INNER WEST COUNCIL

DEVELOPMENT ASSESSMENT REPORT

Application No.	D/2018/189
Address	67 Ballast Point Road, BIRCHGROVE NSW 2041
Proposal	Lower ground, ground and first floor alterations and additions to existing dwelling-house, and associated works, including construction of a new swimming pool at rear, tree removal and replacement of a shed.
Date of Lodgement	17 April 2018
Applicant	Vaughan Architects Pty Ltd
Owner	Mr R L Freeman and Mrs K J Freeman
Number of Submissions	Objections from 6 properties
Value of works	\$957,500
Reason for determination at Planning Panel	Demolition of a portion of the heritage item
Main Issues	<ul style="list-style-type: none"> • Impacts to heritage item • Bulk and scale • Impacts to trees on adjoining properties • Visual privacy
Recommendation	Deferred commencement
Attachment A	Recommended conditions of consent
Attachment B	Plans of proposed development

DRAWING:	DRAWING NO:
PROPOSED GROUND FLOOR PLAN & DEMOLITION PLAN	DA05
SCALE: 1:100	DATE: 24.10.18
CLIENT: Author	ISSUE: 3
PROJECT: Project Number

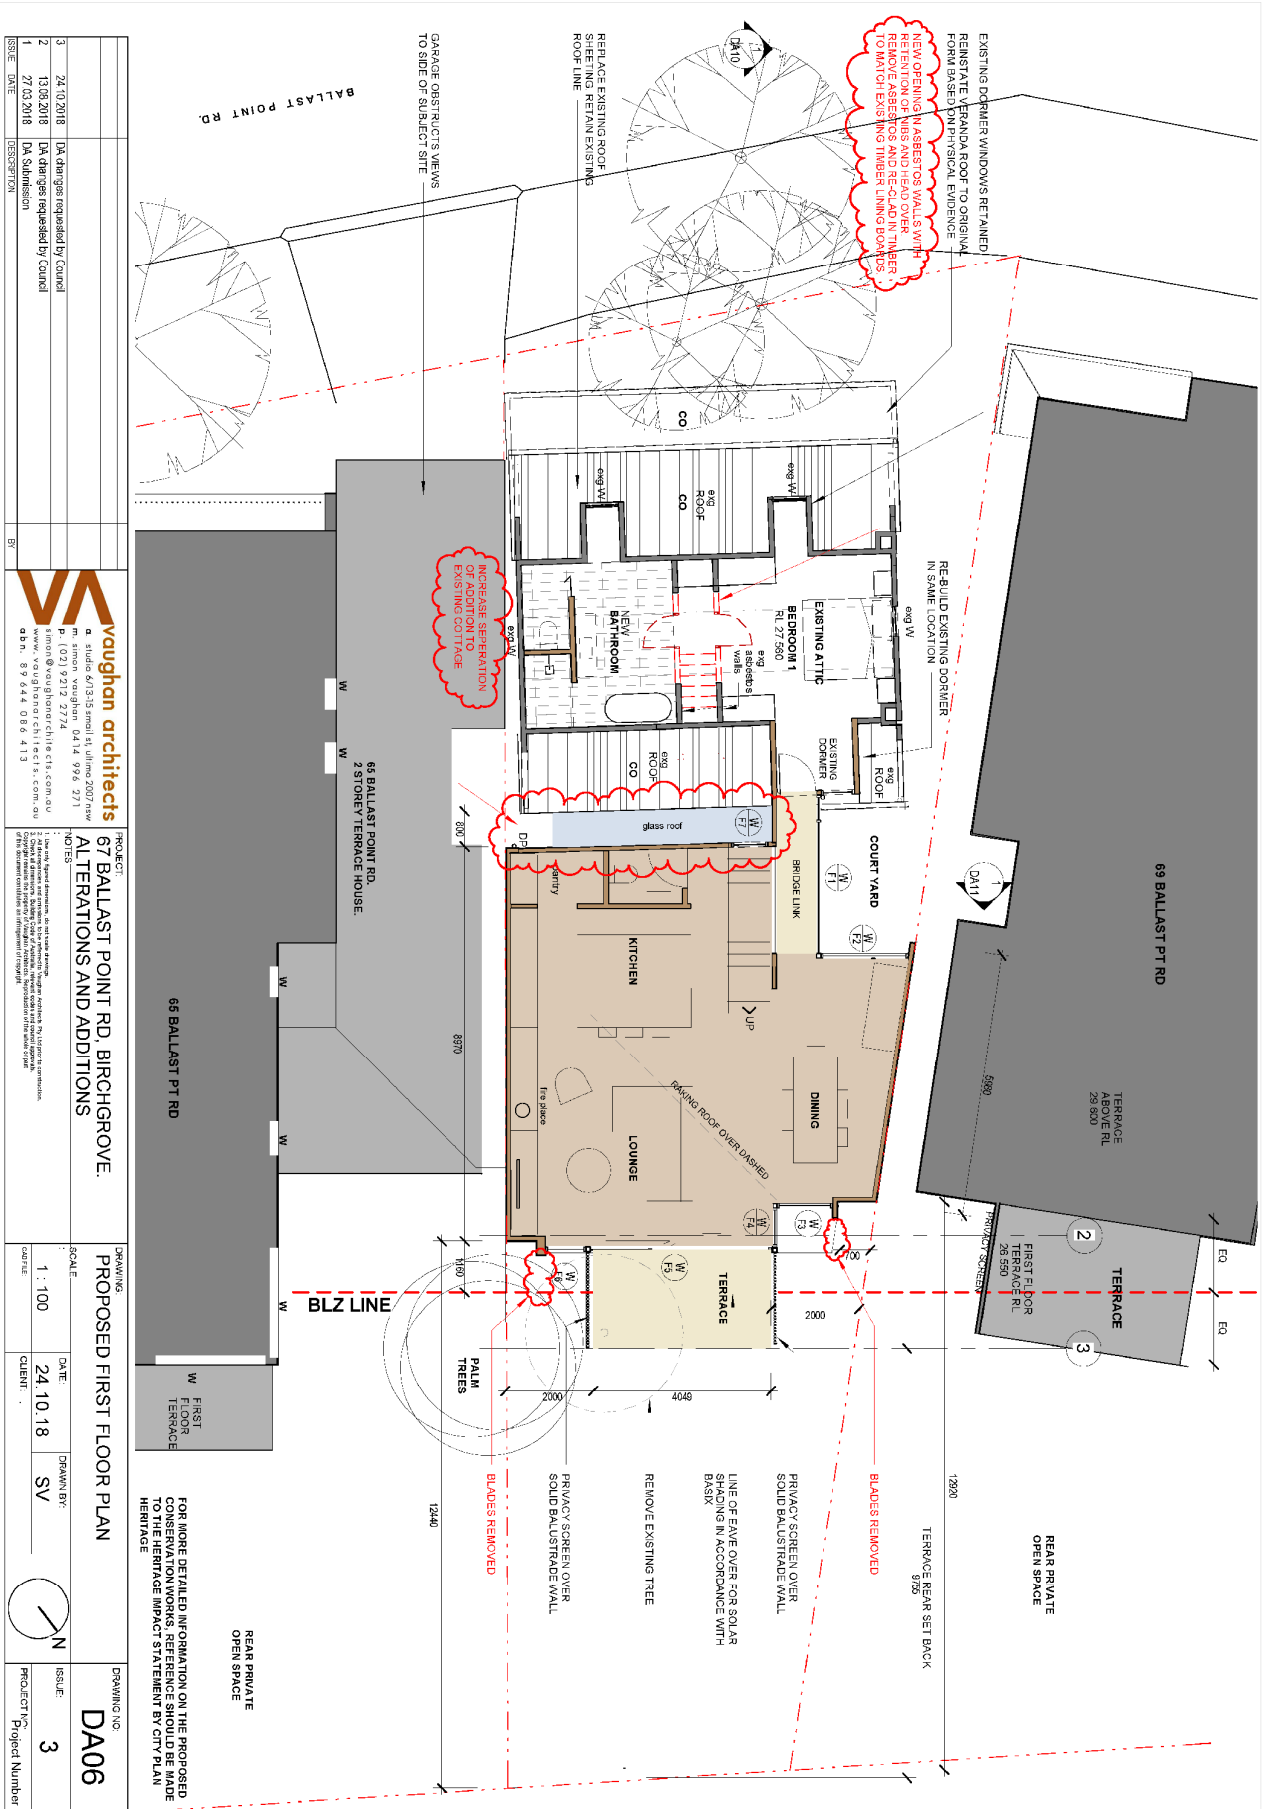
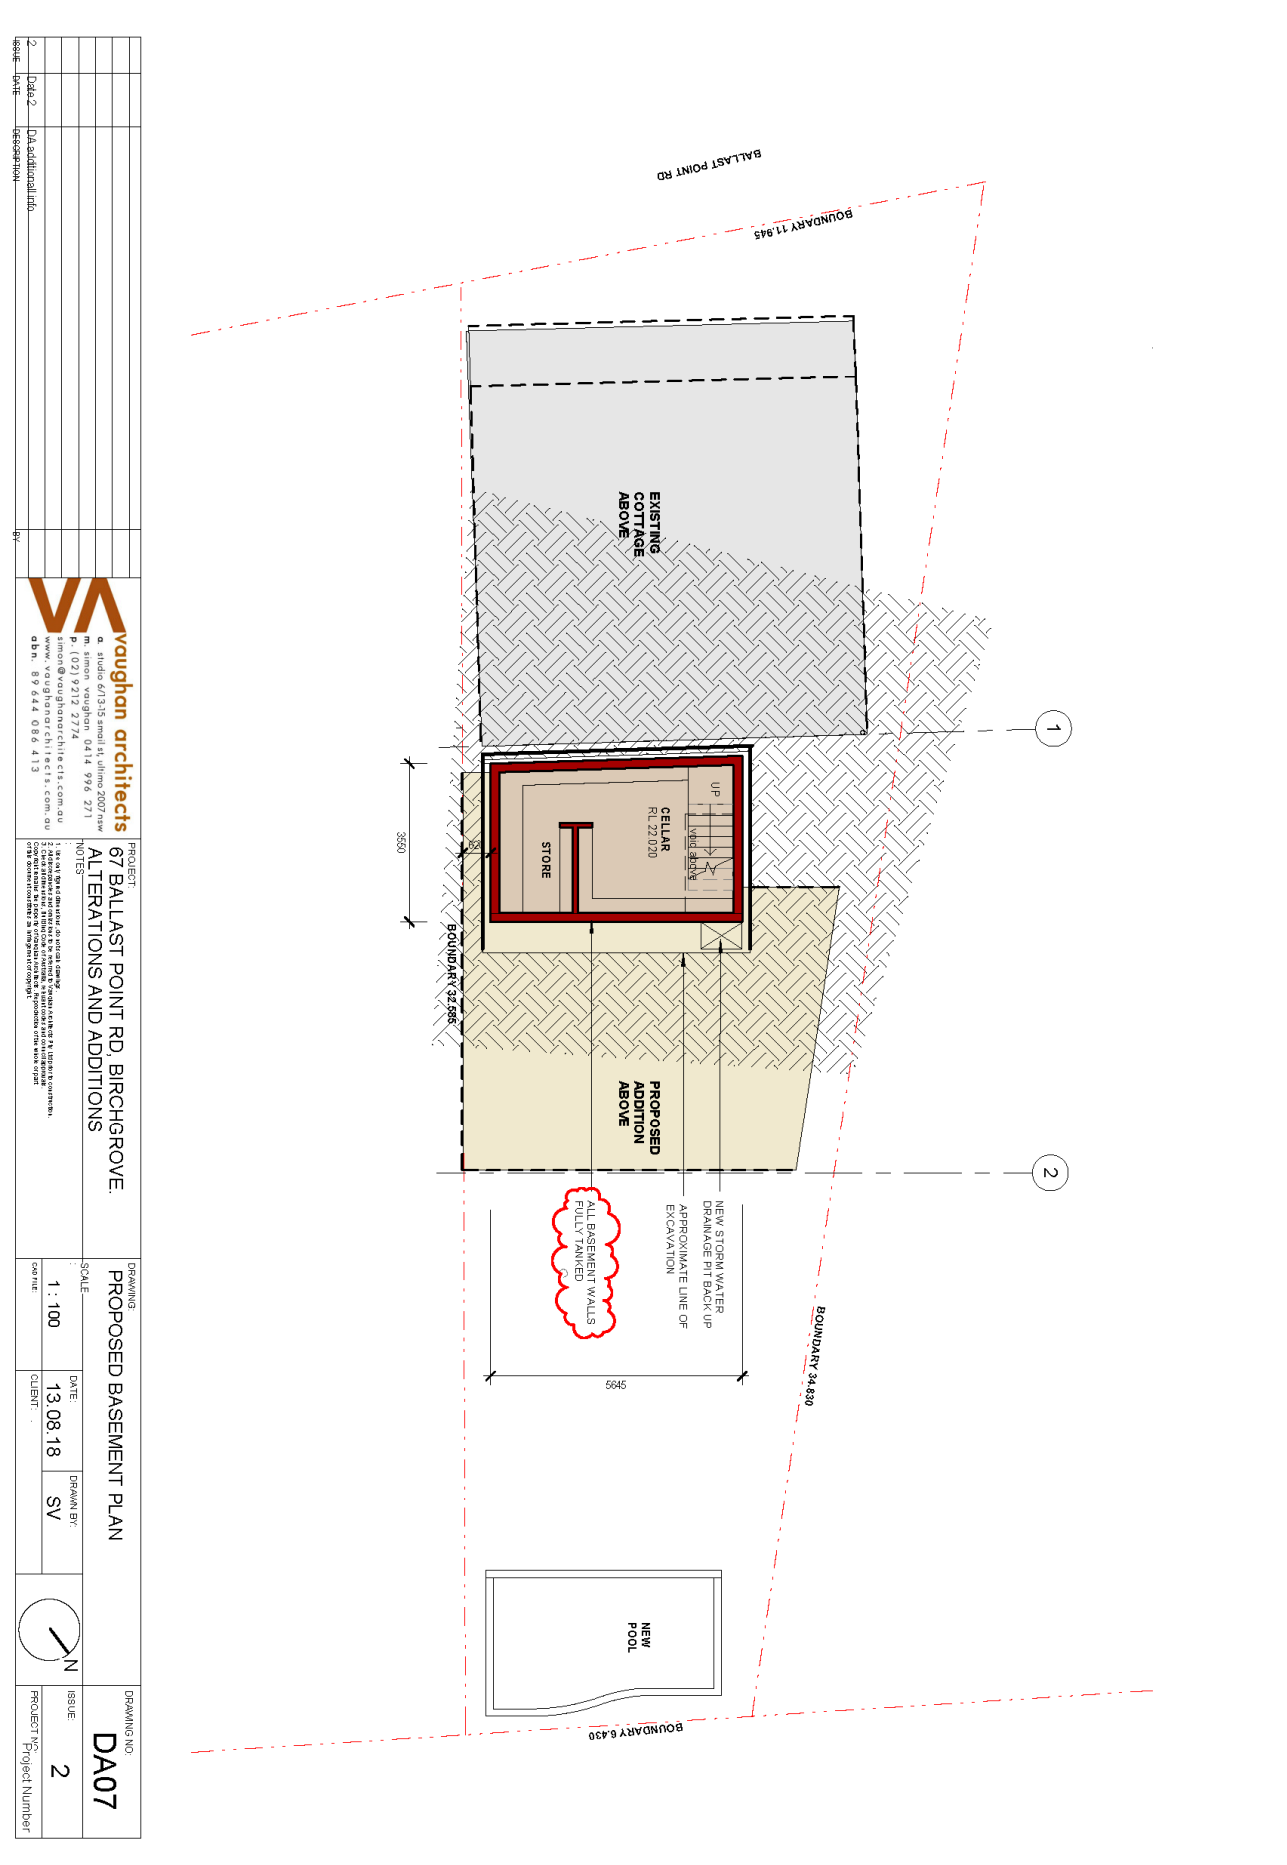
A review of the submitted *Site/Ground Floor Plan*, prepared by *Quantum Engineers*, dated 11/04/2018, DWG No. D2 has shown two *Leptospermum petersonii* (Lemon Scented Tea Tree) located at the front of the site to be impacted by a 100mm DIA charged line to the rain water tank.

The applicant was requested to amend the design of the *Site/Ground Floor Plan* and pool design/location to ensure that all excavation and required services are excluded from TPZ of trees to be retained. The submitted *Stormwater Plan*, prepared by *Quantum Engineers*, DWG No. D2, Revision C, dated 13/08/20128 has been amended to avoid possible root incursions for two *Leptospermum petersonii* (Lemon scented tea tree) located at the front of the site in response to previous comments made on the 26th July, 2018.

Comment: If the pool was supported, a condition would have been recommended to ensure the pool would comply with the provisions of the pools act. However, the pool will be required to be deleted via a deferred commencement condition due to potential impact to trees on the rear adjoining property.

Comment: The proposed pool which is predominated located at below ground pool and have maximum levels at RL23.300 will result in acceptable impacts to the adjoining properties, however, the proposed pool will be conditioned to be deleted from the proposal due to potential impacts to the trees located at 26 Wharf Road.

- b) The proposed pool is to be deleted from the proposal.
 - c) The stair and wall that were demolished recently in the front portion of the dwelling is to be reinstated to their former detail, complete with door frame, architraves, threshold and highlight, and the former adjoining wall. Detailed drawings shall be submitted to Council showing the proposed reinstatement.

SITE/GROUND FLOOR PLAN
 1:150

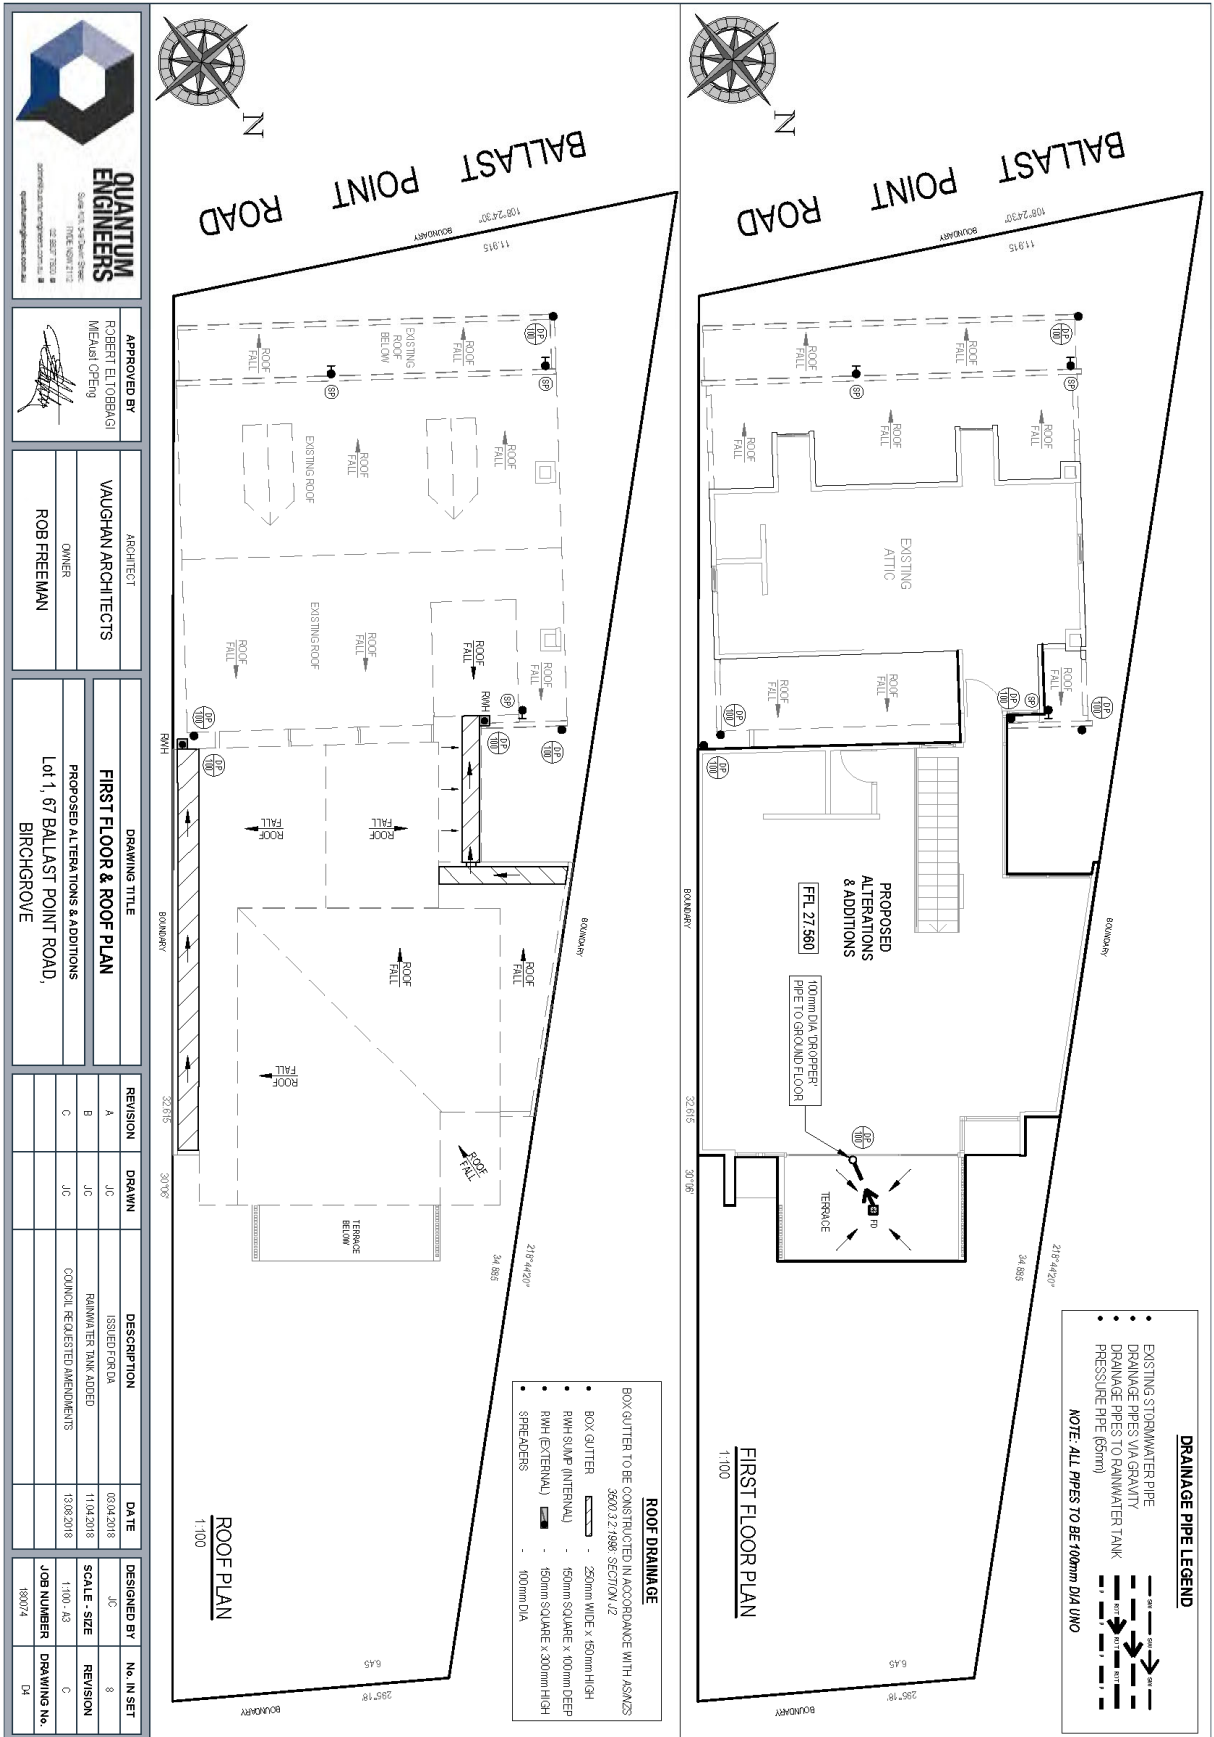
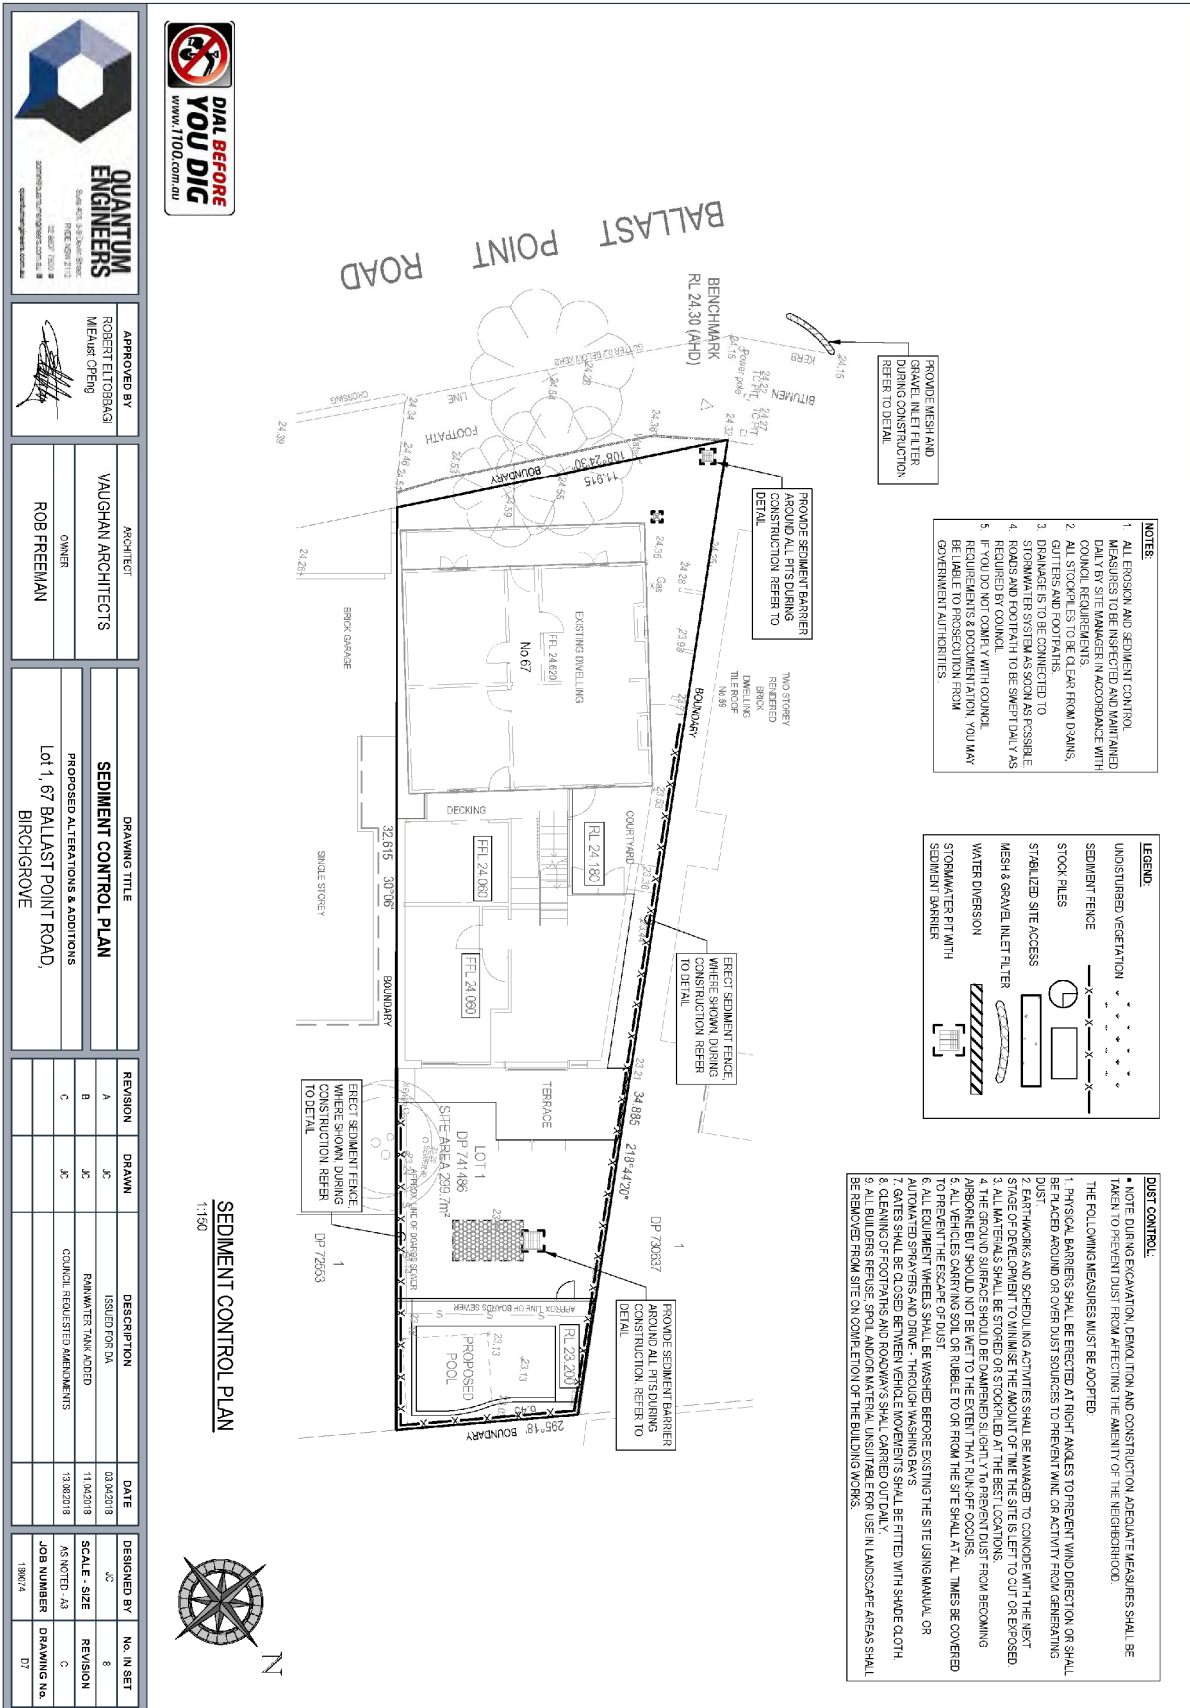
The revised stormwater drainage concept plan proposed an absorption trench of approximately 800mm depth. This is not a feasible proposal given the geotechnical report indicates sandstone at a depth of 600mm. An alternative proposal for disposal of stormwater that is unable to drain to Ballast Point Road by gravity is required. This will be addressed by a deferred commencement condition.

- d) The privacy screens on the eastern and western sides of the first floor balcony are to have 1 metre returns on the north side of the balcony.
2. A Stormwater Drainage Concept Plan (SDCP) on Drawing No 180074-D1 to D8 Revisions C and prepared by Quantum Engineers and dated 13.08.18 shall be amended to make provision for the following:

- a) Provide a suitable on-site dispersal system to cater for minor roof and paved areas at the rear of the property that cannot reasonably be drained by gravity to the Ballast Point Road, with consideration of the shallow depth to sandstone bedrock, that addressed the following:
